Murray City Hearing Officer Meeting
June 8, 2022, at 12:30 p.m.

| AGENDA ITEM #2 - Suzanne Hoggan | | | |
| REQUEST: | The applicant is requesting a variance to Section 17.76.140(H) of the Murray Land Use Ordinance, which requires installation of a 4-foot landscape strip adjacent to the drive access to the rear lot in flag lot subdivisions. | | |

Figure 1: Aerial view of the subject property and location of variance (red line) alongside the site plan showing the specific location for the 4-foot landscaping variance for a length of 30 feet.

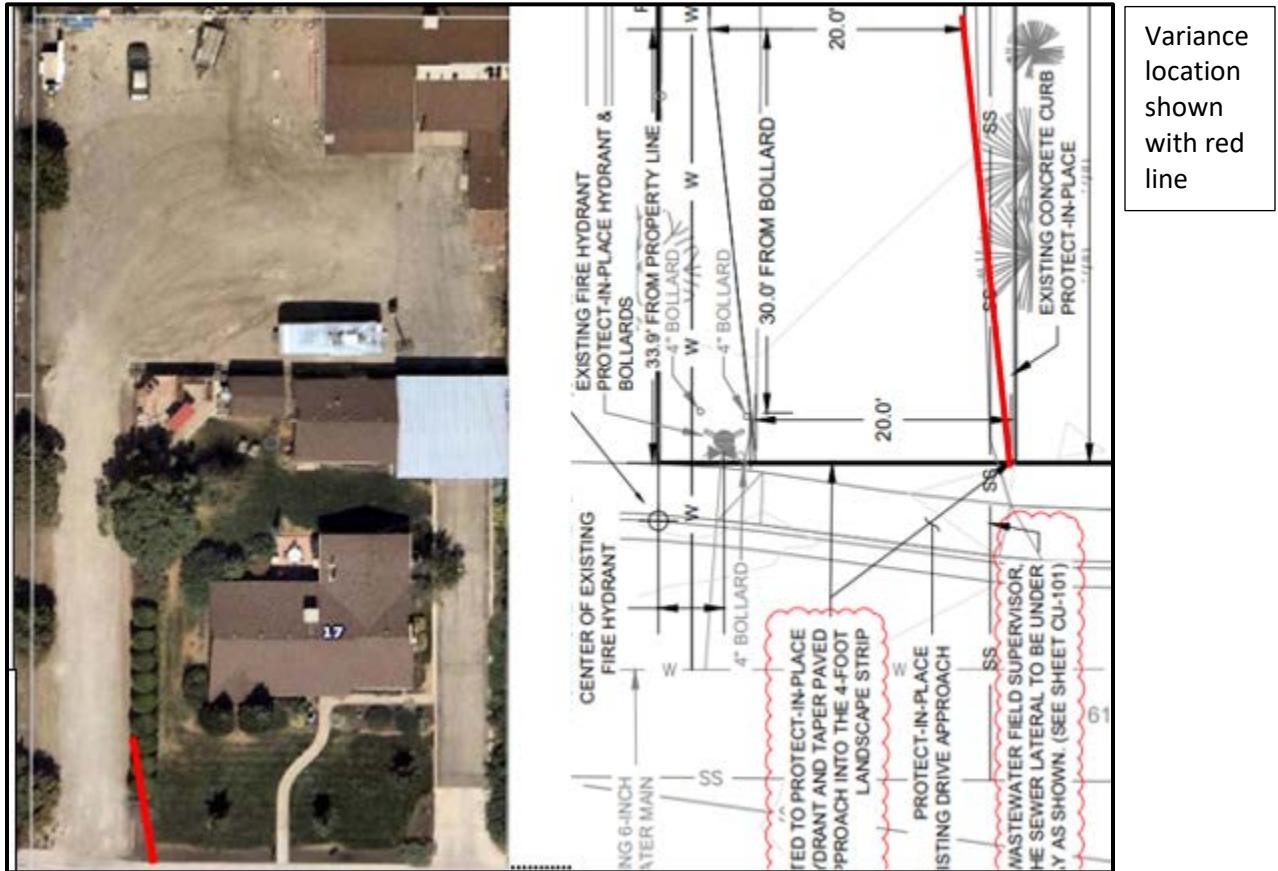
There is an existing fire hydrant set 5.2' at the southwest corner of the property with protecting bollards that encroach into the 28' flag lot right-of-way. The fire hydrant extends into the driveway (hard surface) required by the Fire Department. In order to meet the 28' drive access the applicants are seeking a variance to not install the required 4 feet of buffer landscaping along the east side for a length of 30 feet. This request will be virtually

unnoticeable because of the existing concrete curb and landscaping to the east of the drive access. The existing concrete curbing provides for a natural property line. The variance request shows the drive access having a slight curve from the south to the north due to the fire hydrant and bollards encroaching into the property beyond the 4-foot-wide landscape strip. (See plan below):

The Murray City Fire Marshall has indicated that they are comfortable with this request provided that the drive access have a hard surface minimum width of 20'.

Based on review and analysis of the application materials, the subject property, surrounding area, and applicable sections of the Murray City Land Use Ordinance, Staff finds that the application meets the applicable standards for a variance, and recommends APPROVAL of the requested variance to the requirements of Sections 17.76.140(H) of the Murray City Land Use Ordinance.

HOGGAN FLAG LOT SPLIT
HOGGAN LOT SPLIT SITE
LAYOUT & GRADING
OVERVIEW SHEET
17 EAST 6150 SOUTH, MURRAY, UTAH

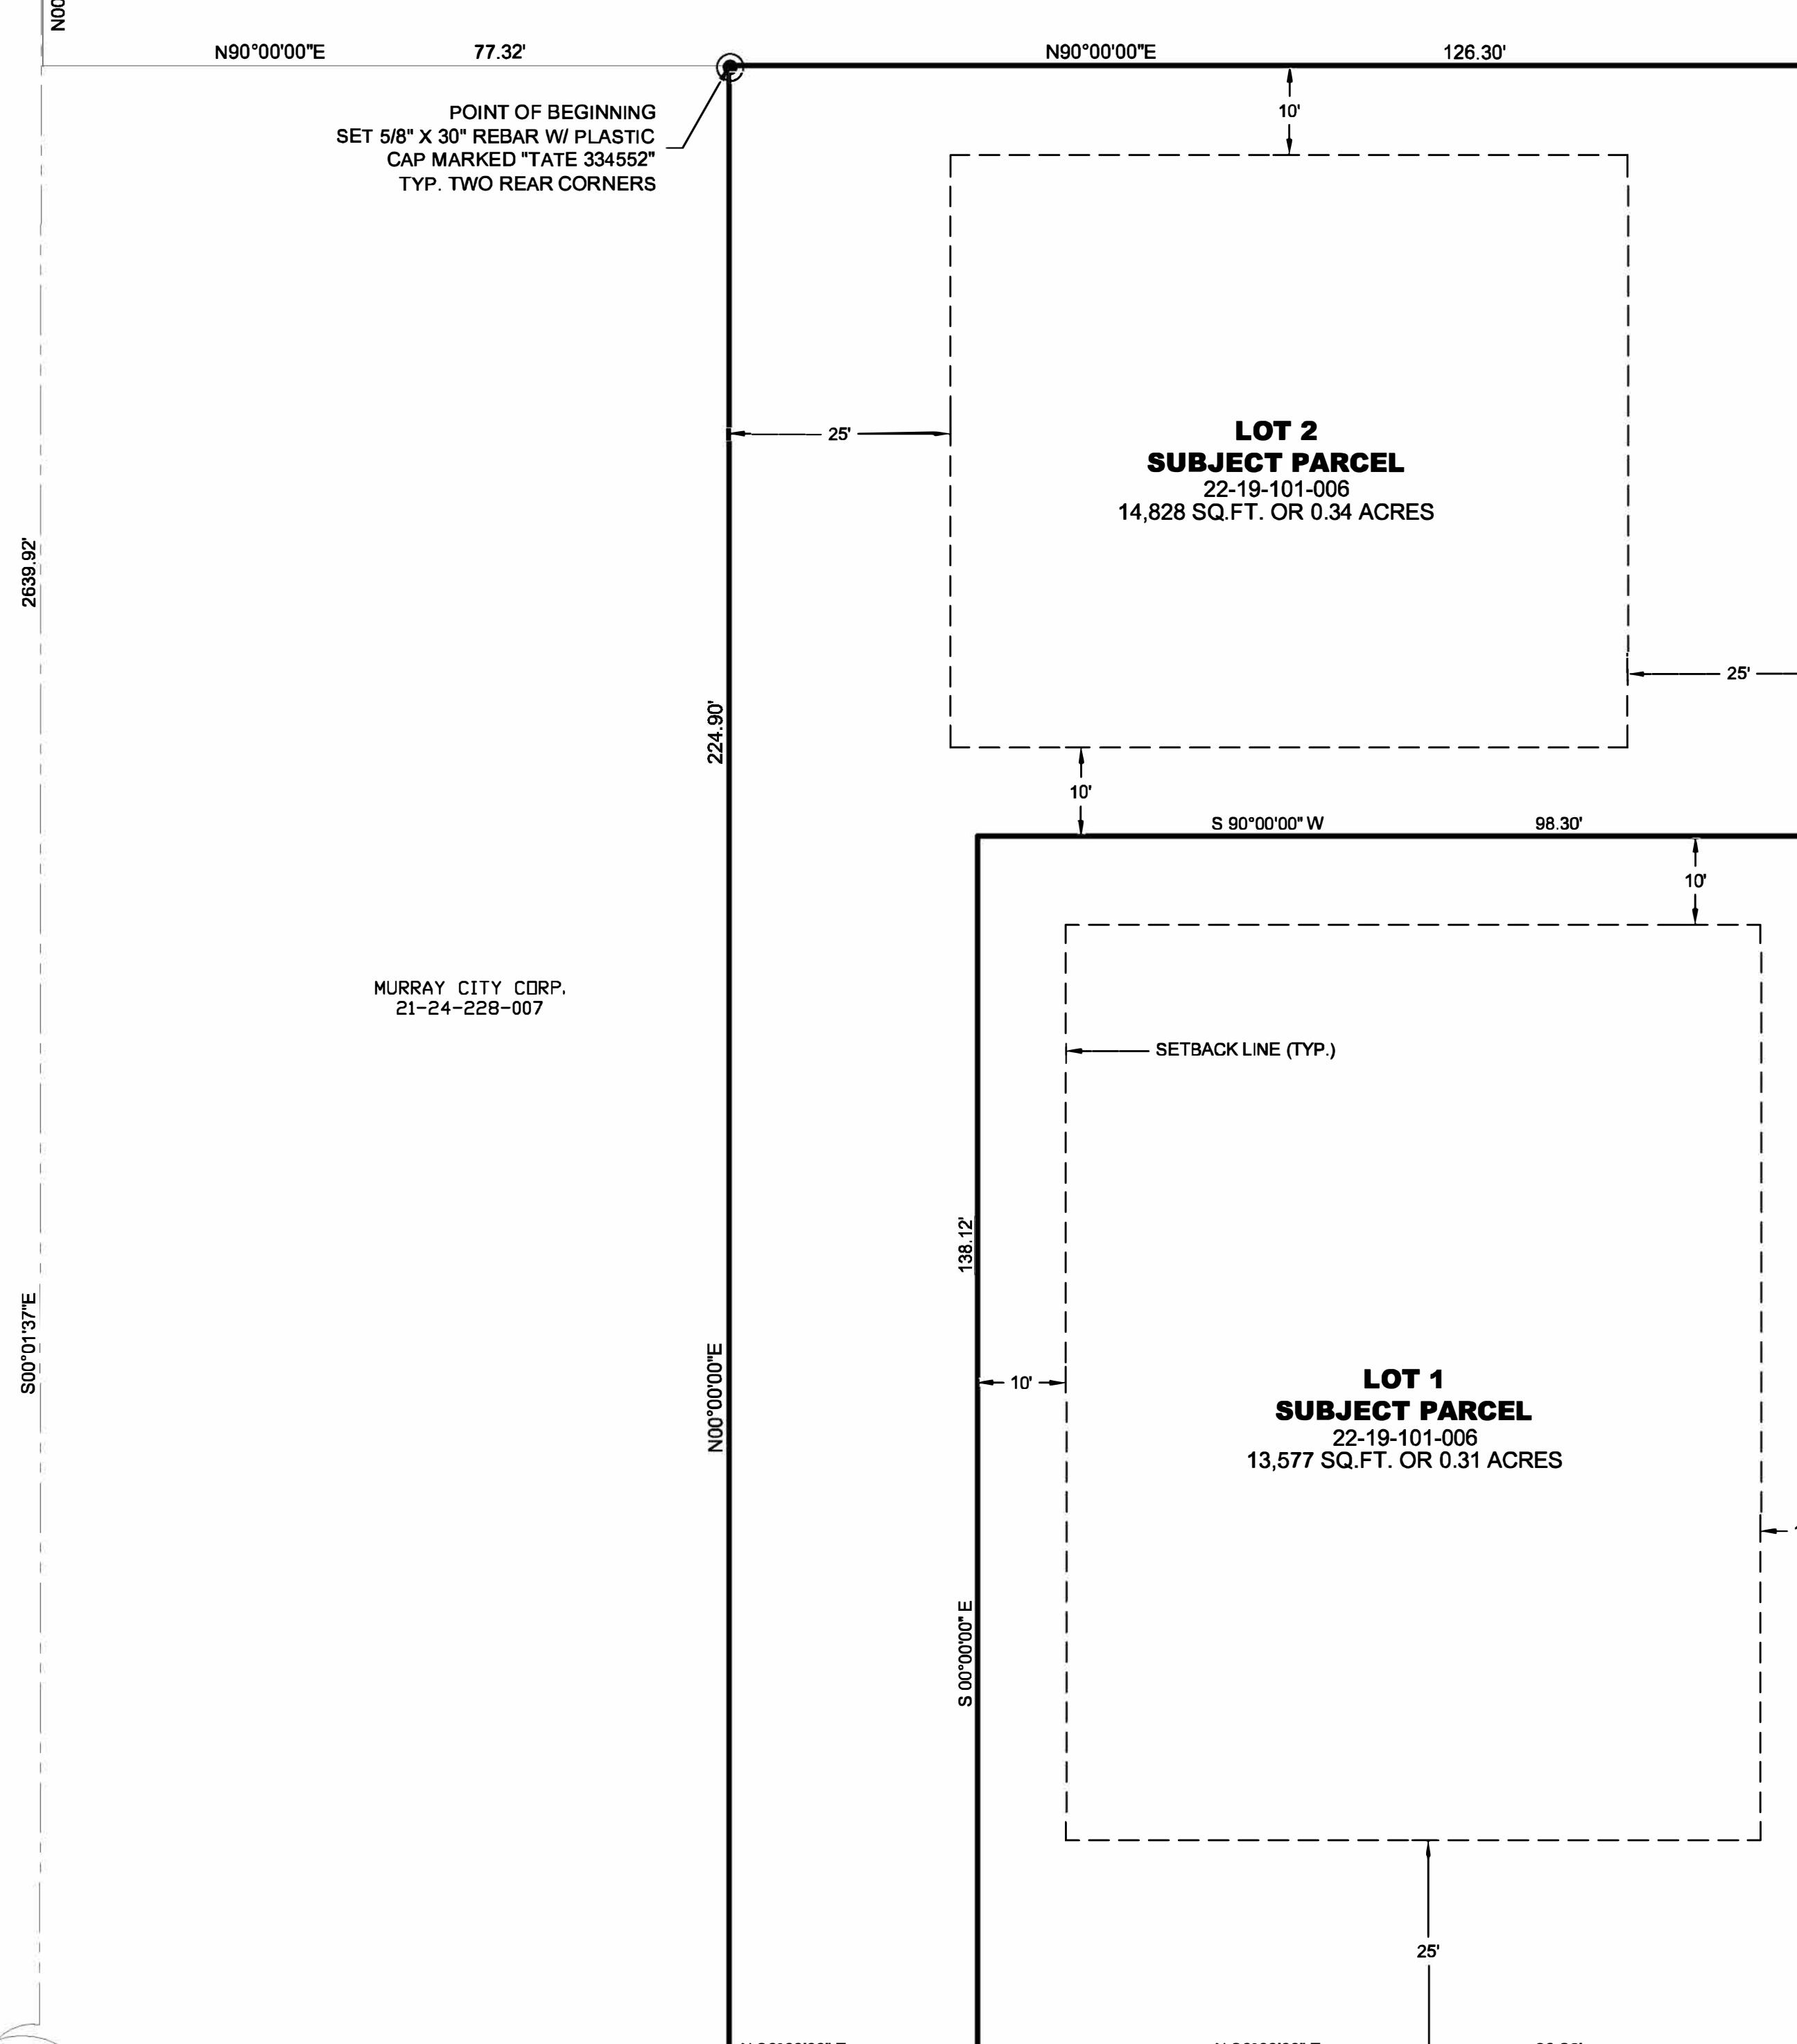
1. An existing fire hydrant was installed 5.2' from the southwest property corner in the Flag Lot drive approach. Murray City Code, Chapter 17.76, Section 17.76.140, Part H states the drive approach shall be at least 28-feet wide, containing 4-foot-wide park strips on either side of a 20-foot-wide paved drive approach section. The proposed Flag Lot Layout calls for Protecting-In-Place the existing fire hydrant and protective bollards. However, if the Flag Lot drive approach is maintained at 28-feet from the west property line, the paved section of the drive approach needs to taper around the existing protective bollards and into the 4-foot landscape strip on the east side of the drive approach (as shown on the construction drawings). In doing so the paved 20-ft wide drive approach will be maintained, but the width of the landscape strip would reduce in the tapered section.
